**PRELIMINARY FINDINGS OF THE
INDEPENDENT PEER REVIEW PANEL
FOR SEISMIC HAZARD STUDIES AT
DIABLO CANYON**

Chris Wills
California Geological Survey,
Chair, IPRP

California Energy Commission Joint Commissioner Workshop
April 27, 2015

Figure 6-43

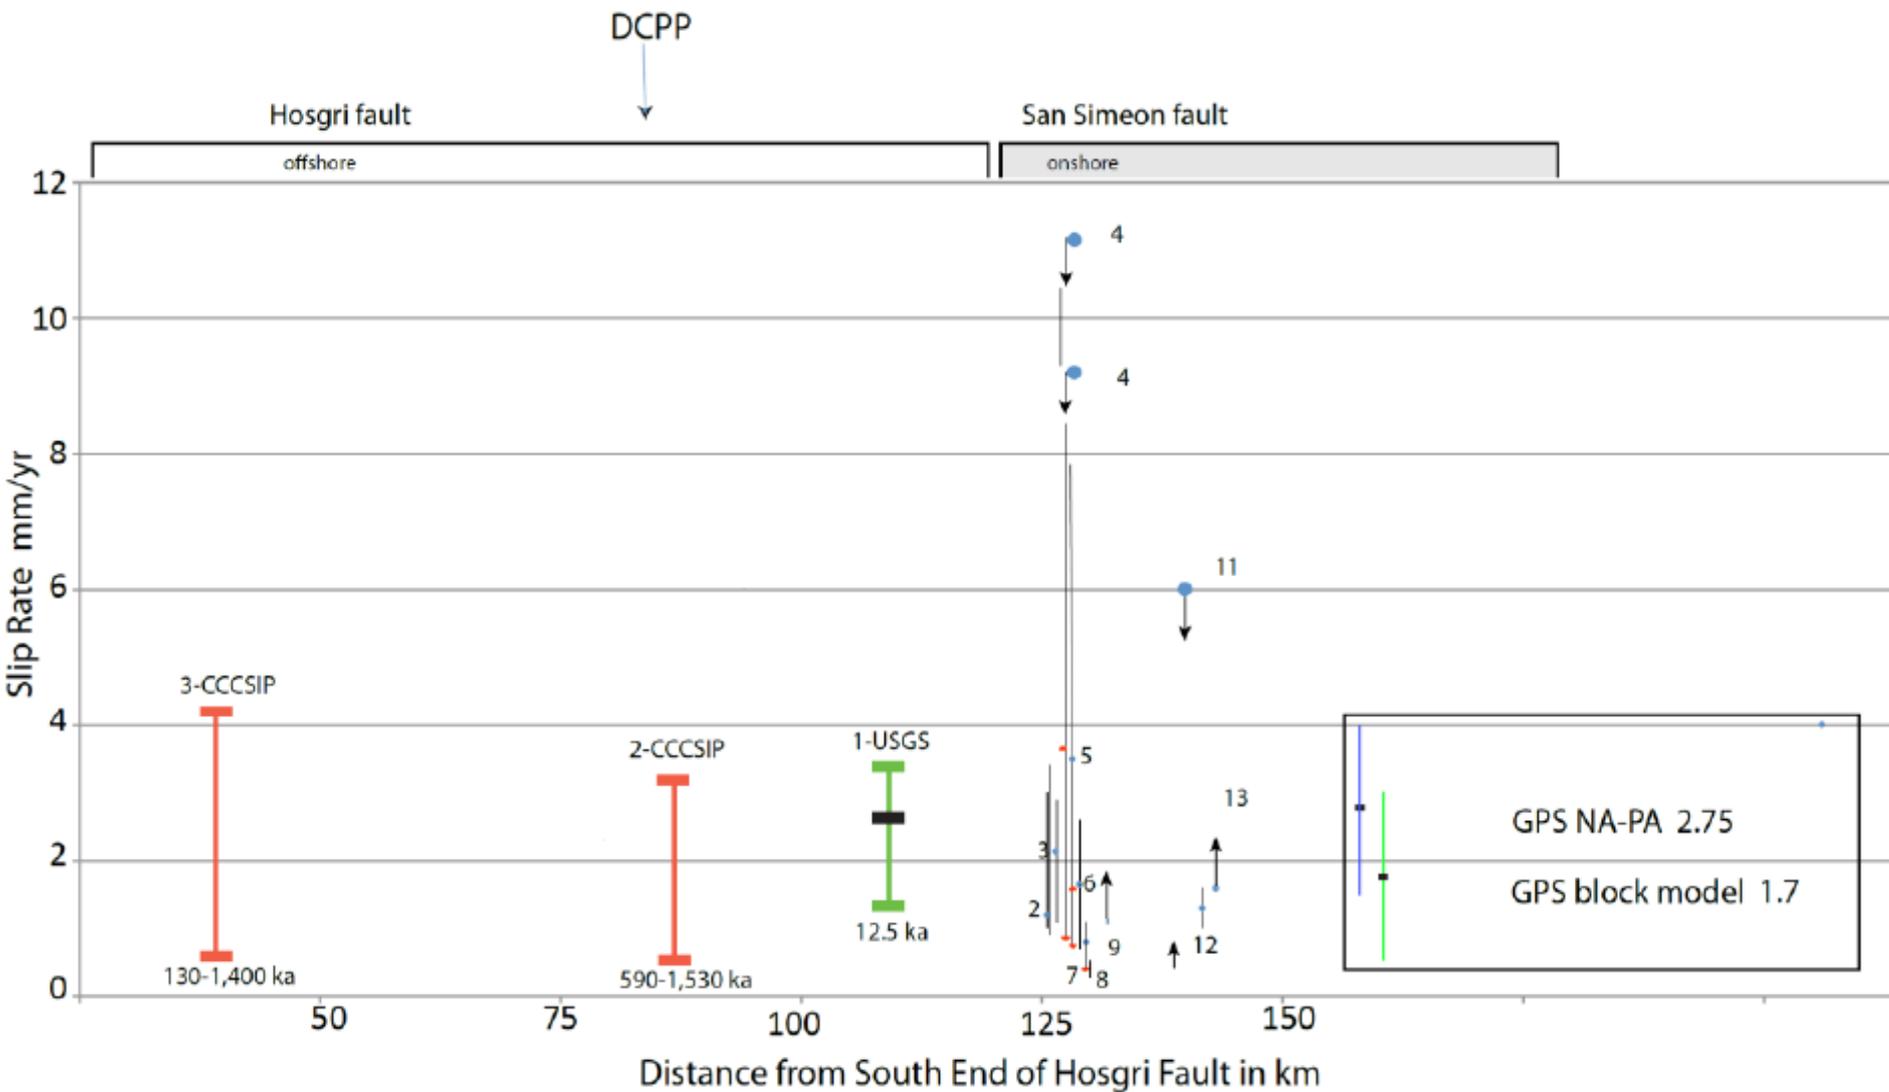
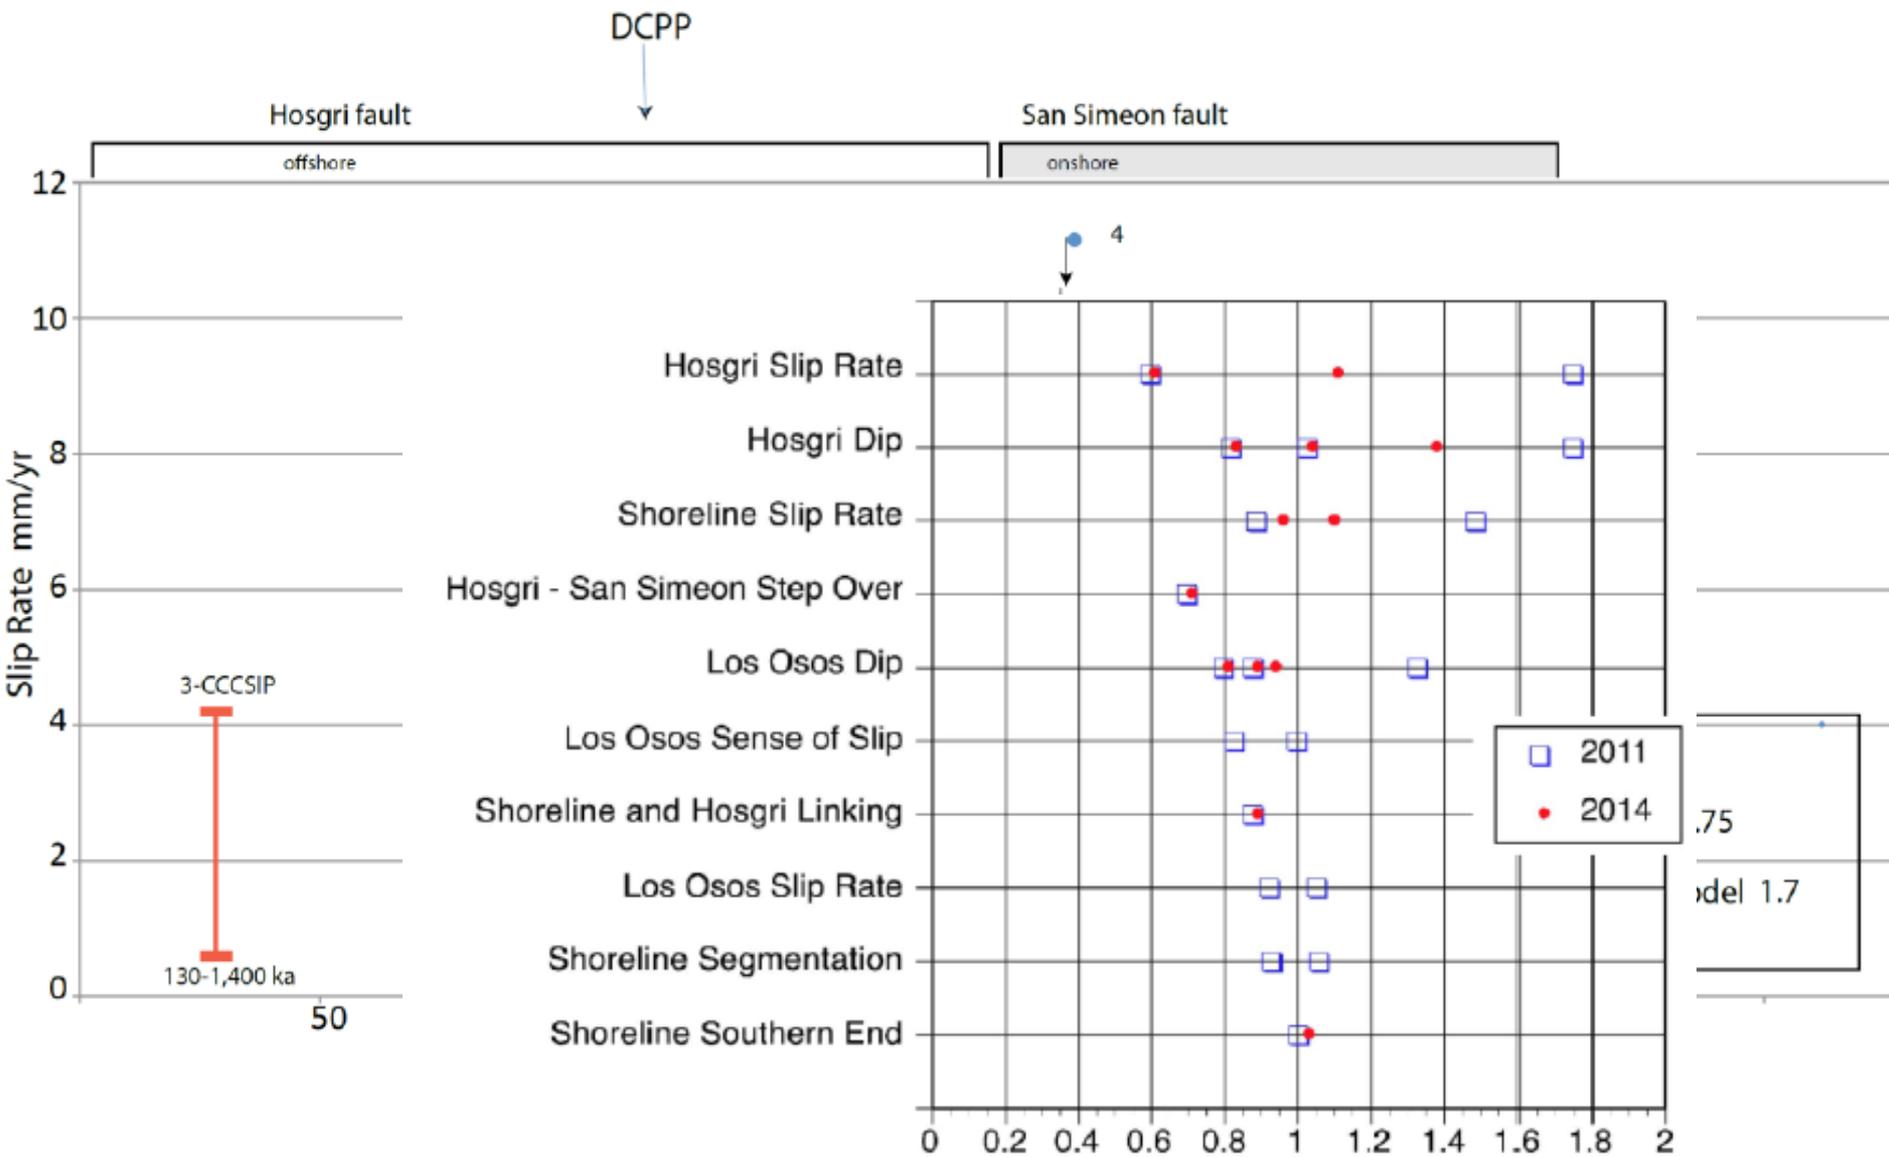
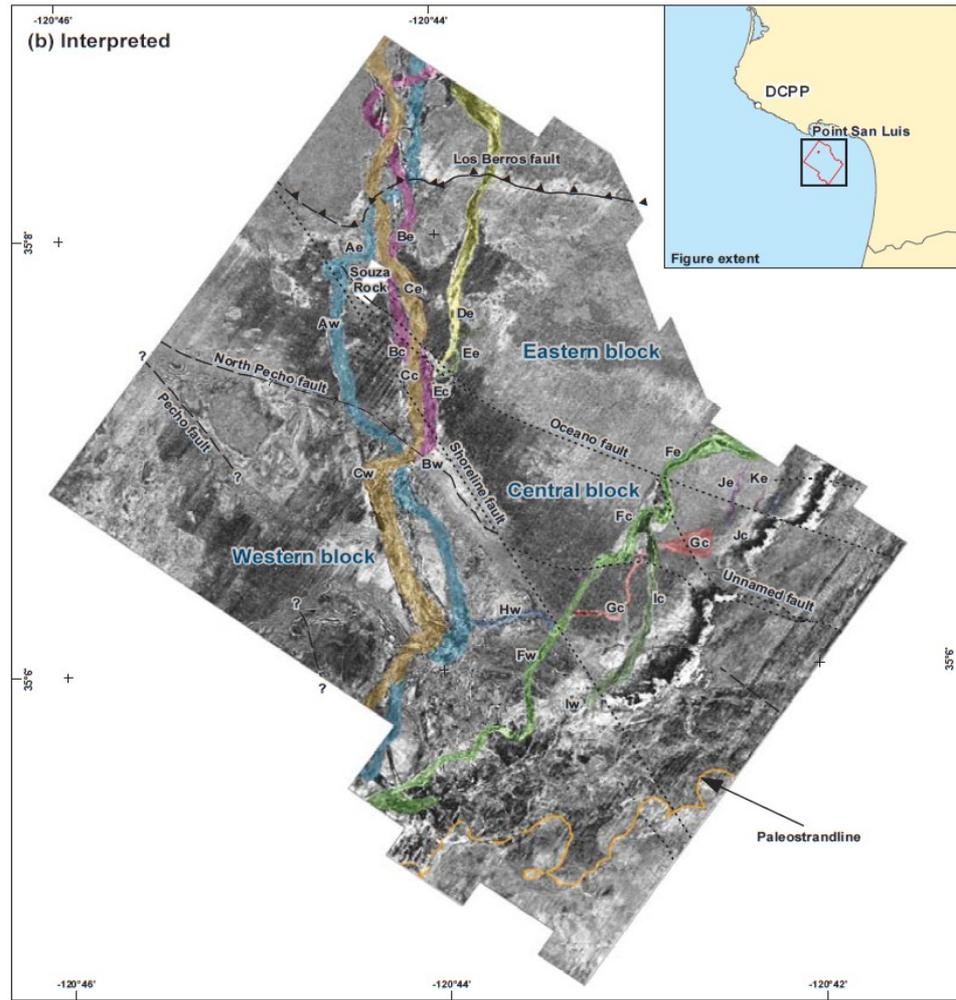
Slip rate on the Hosgri fault

Pacific Gas and Electric Company Figure 7-22

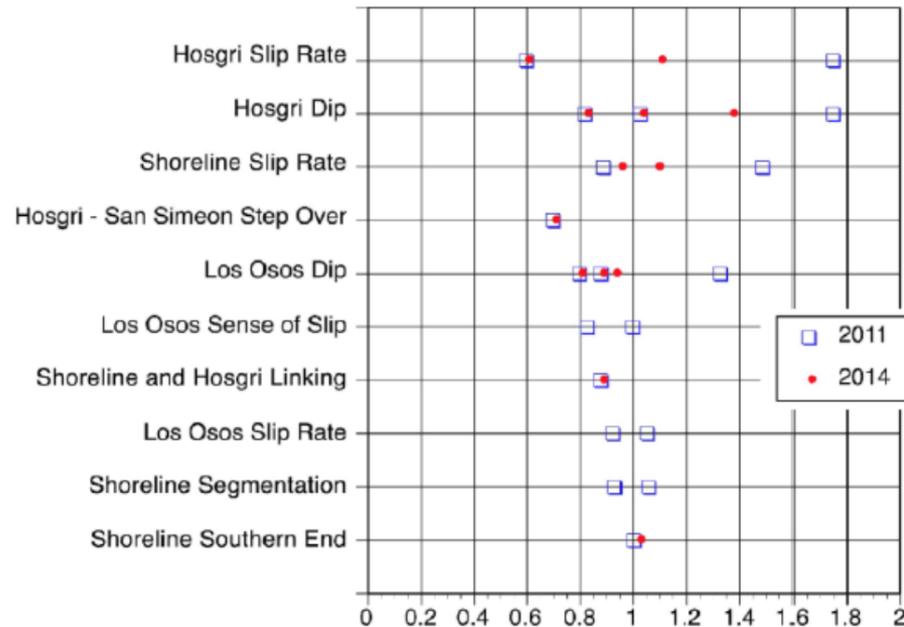
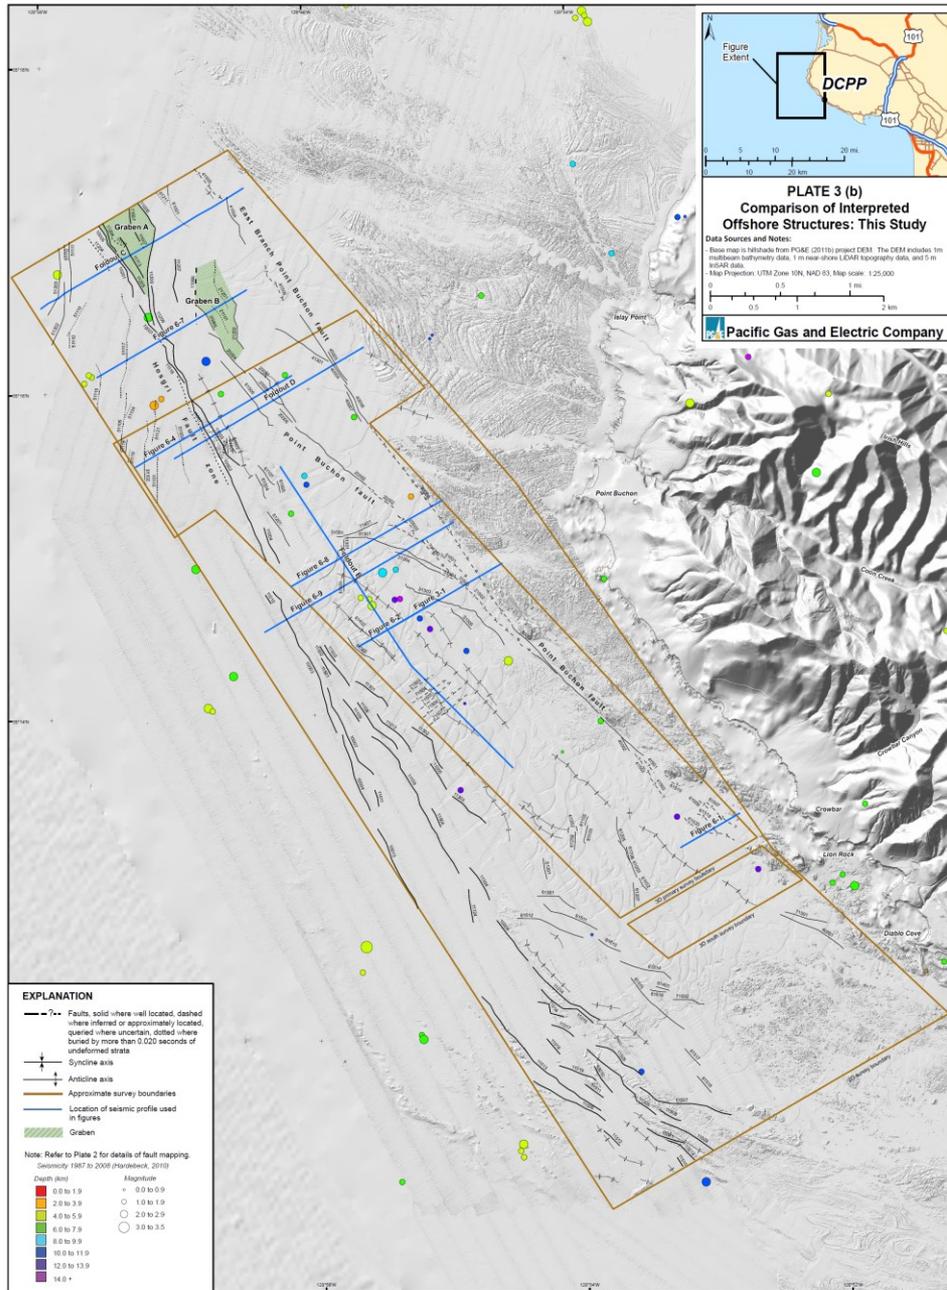
Slip rate on the Shoreline fault:
 Offset of paleostrand line and age estimate allow improved constraints on slip rate.

Dip of the Los Osos fault:

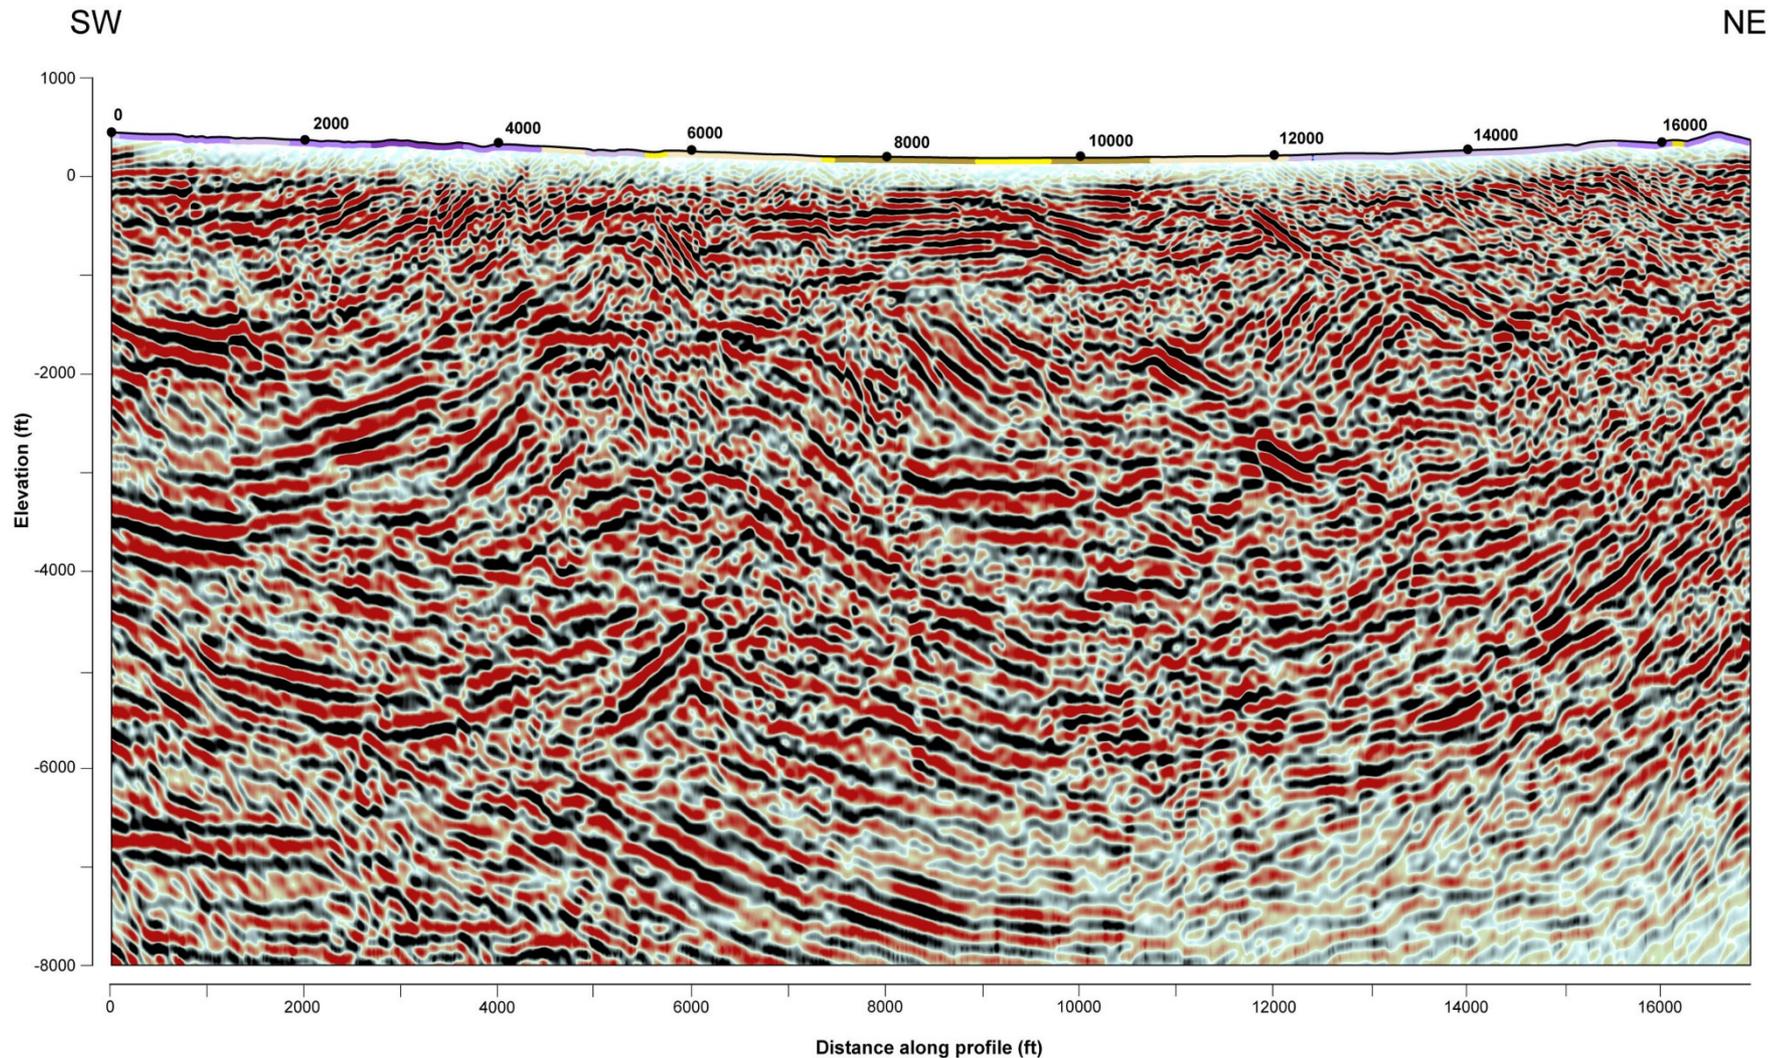
Reflection seismic surveys do not provide convincing constraints on geometry of subsurface faults

Dip of the Los Osos fault:

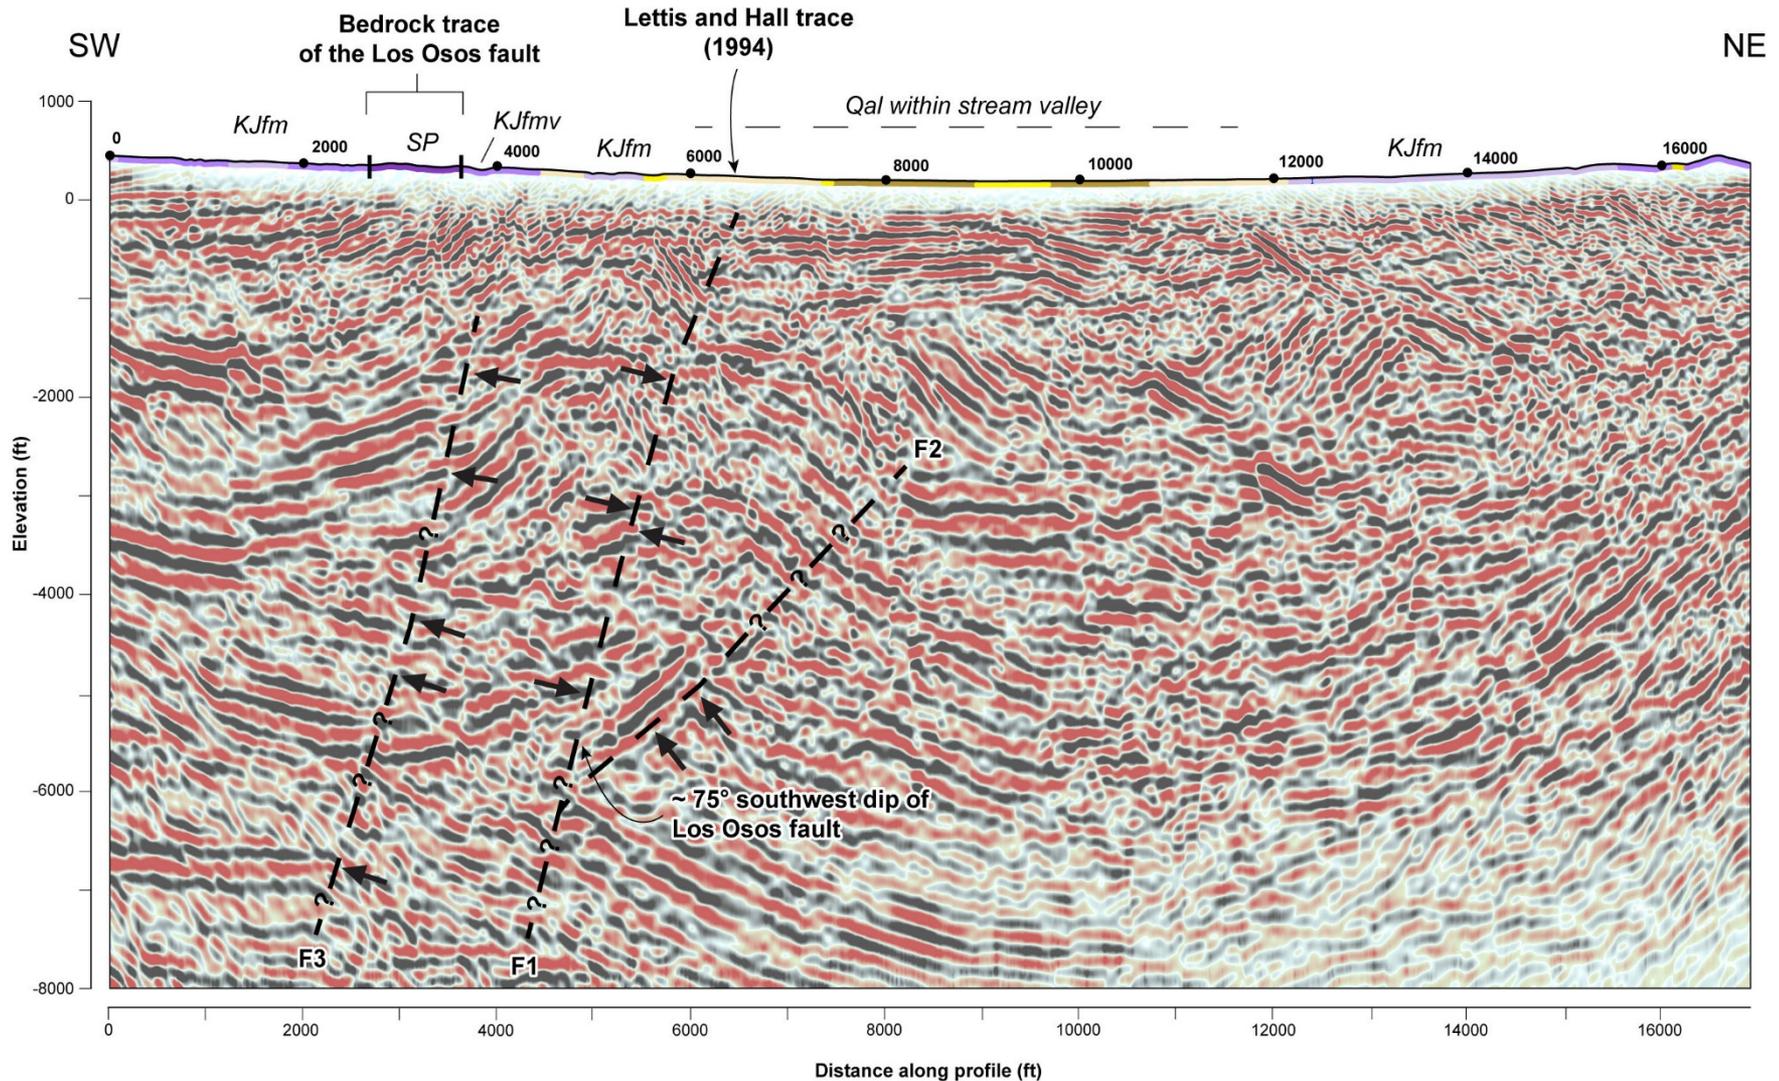
Reflection seismic surveys do not provide convincing constraints on geometry of subsurface faults
